COMPLETE STREETS COMMISSION SPECIAL MEETING AGENDA

6:00 PM - Wednesday, May 21, 2025

- [1.](#) FY24-25 Annual Street Resurfacing Project

2024-2025 ANNUAL STREET RESURFACING PROJECT

IMPROVEMENT PLAN - NEWCASTLE DRIVE

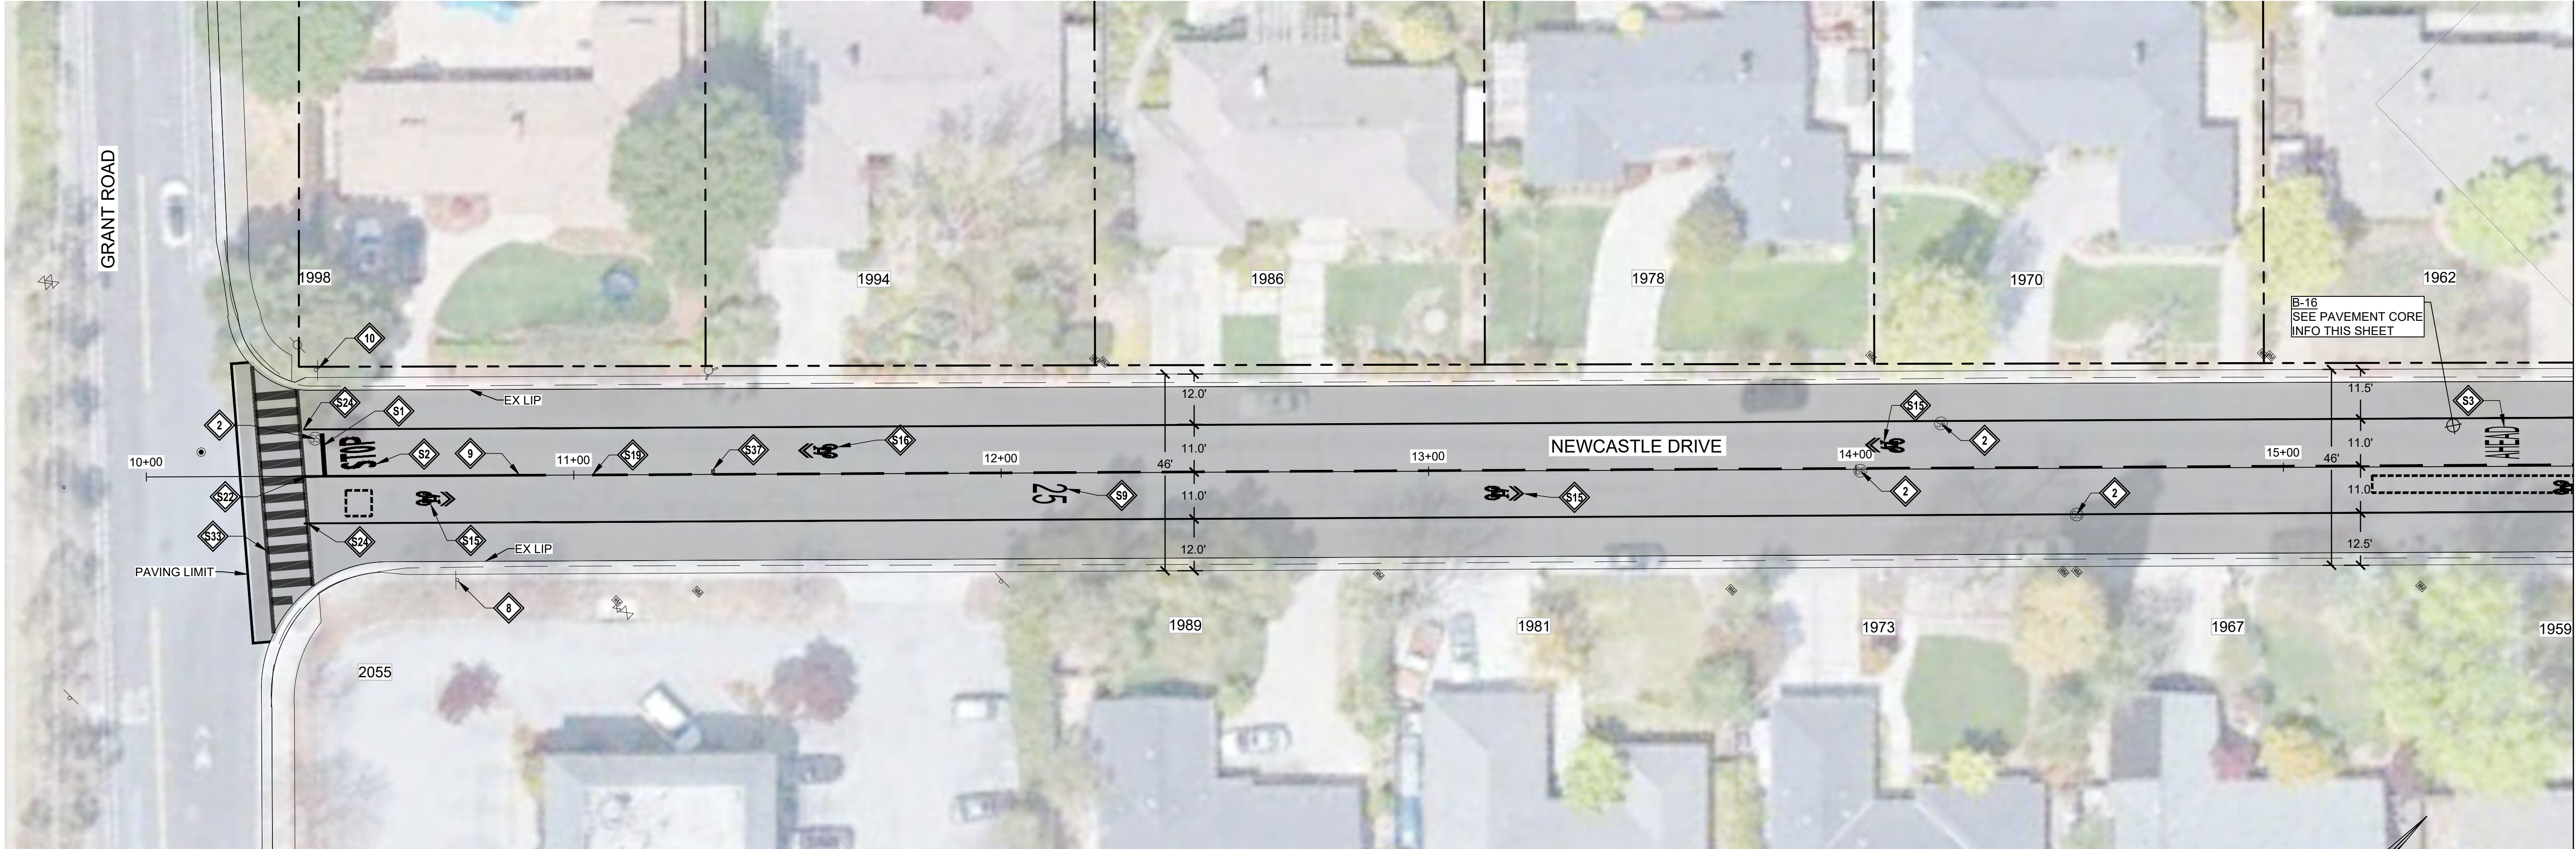
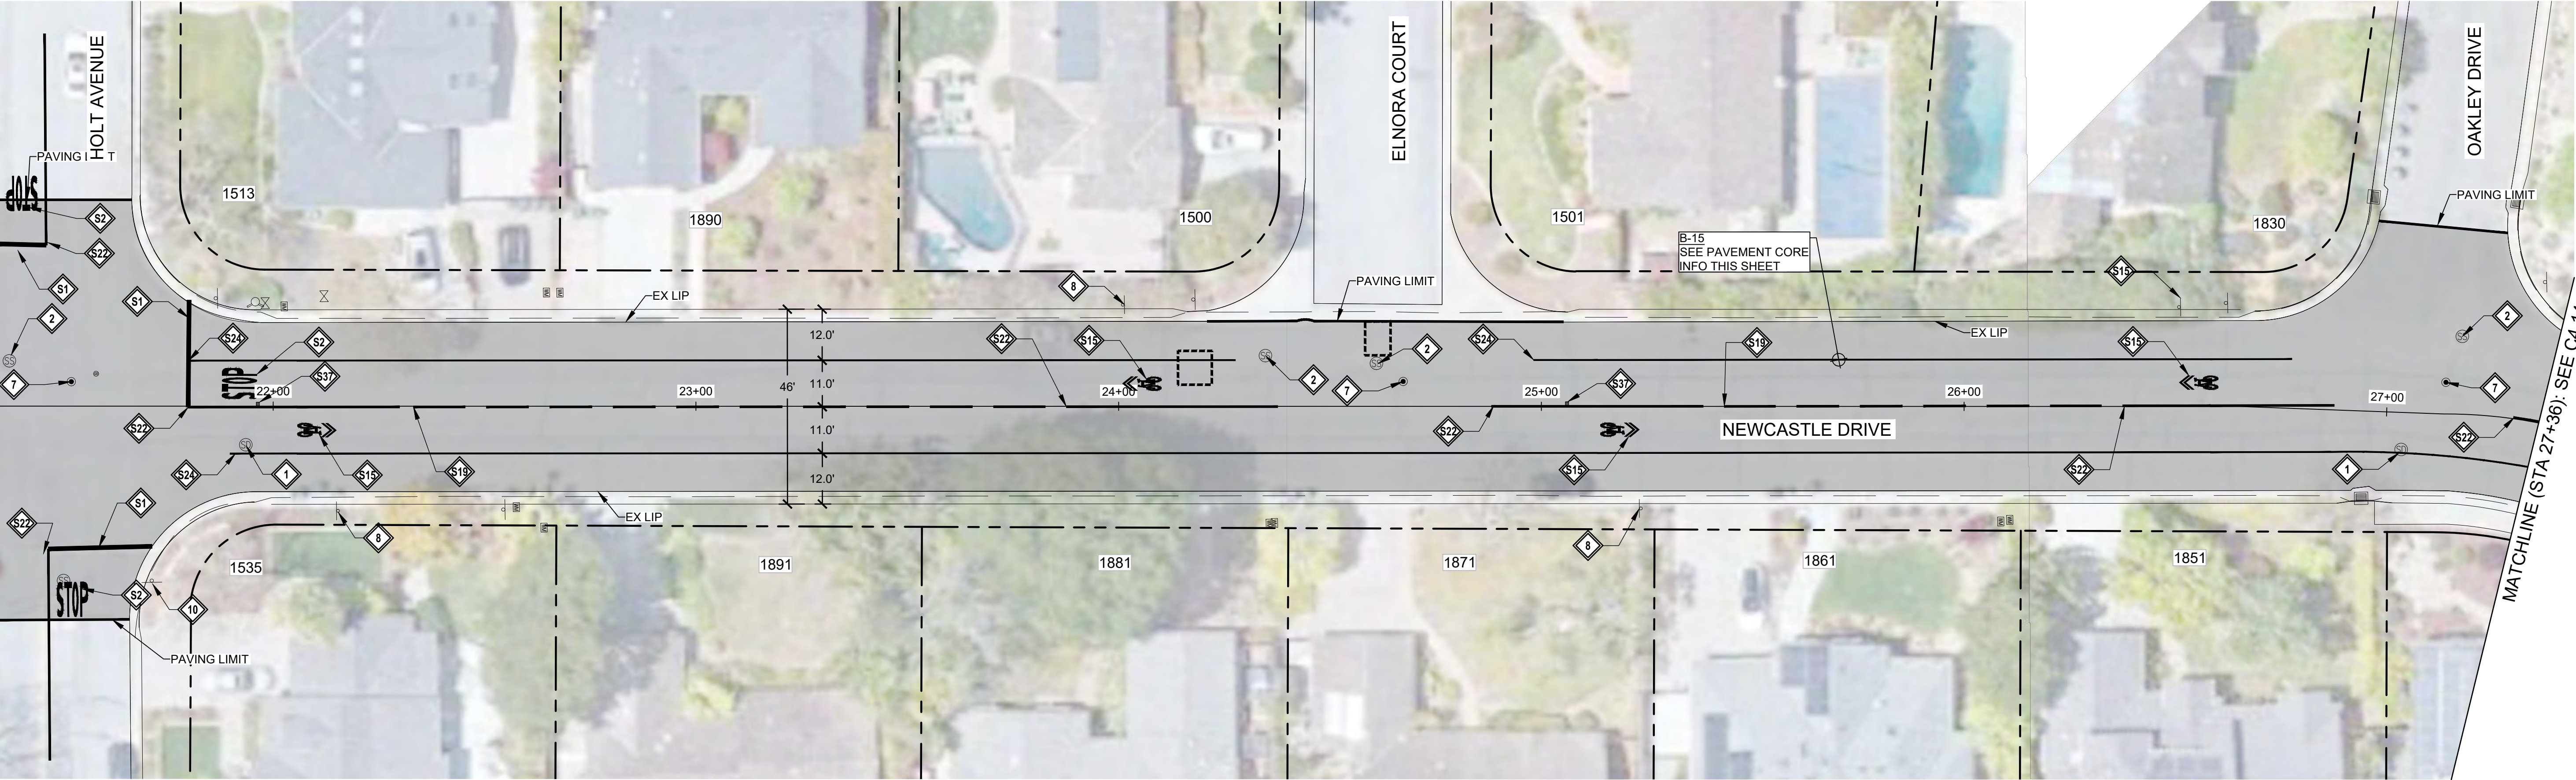
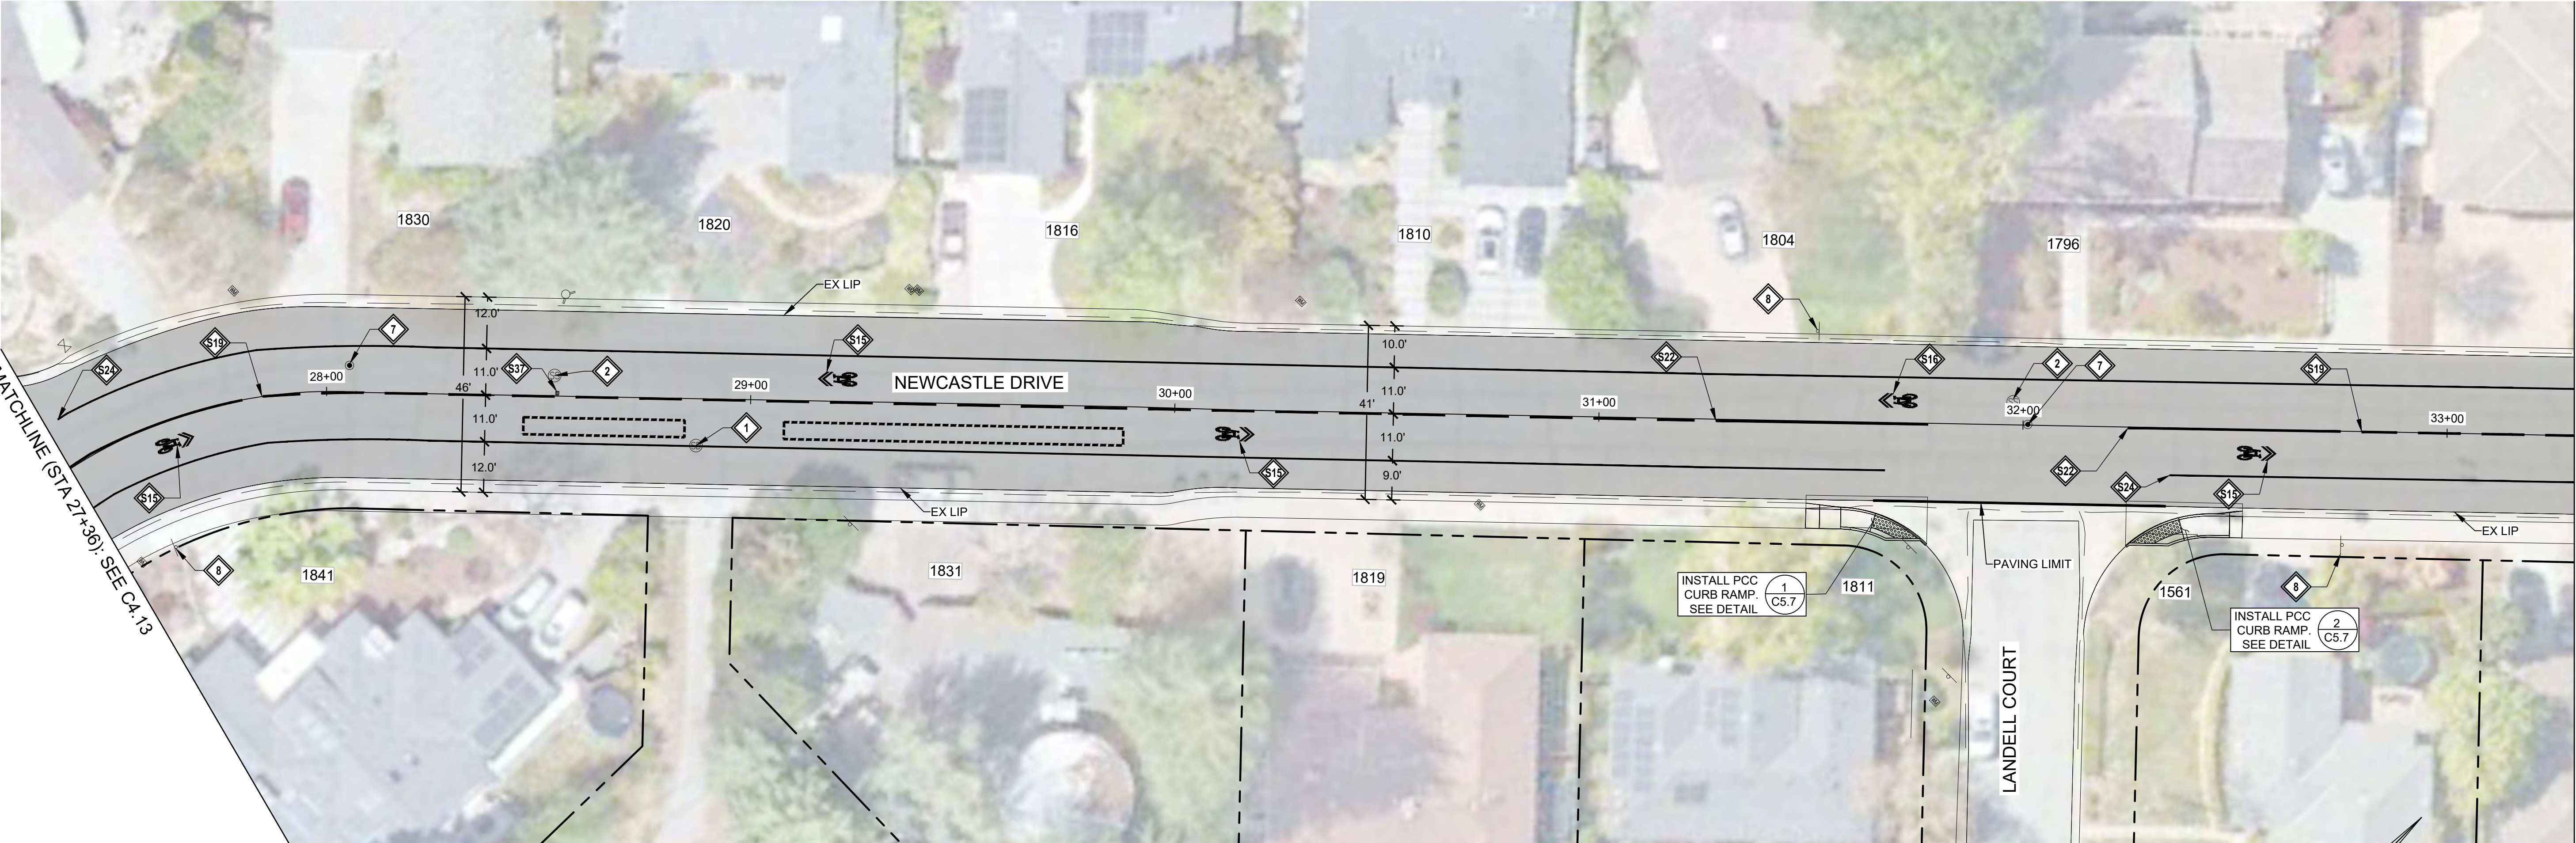
NO to any restrictive parking in front of all residential homes

No to any change in the existing bike paths

6. What impact will the proposed change have on the senior citizens?
7. What impact will the proposed change have on the health and safety of the all residents who live on Newcastle Drive?
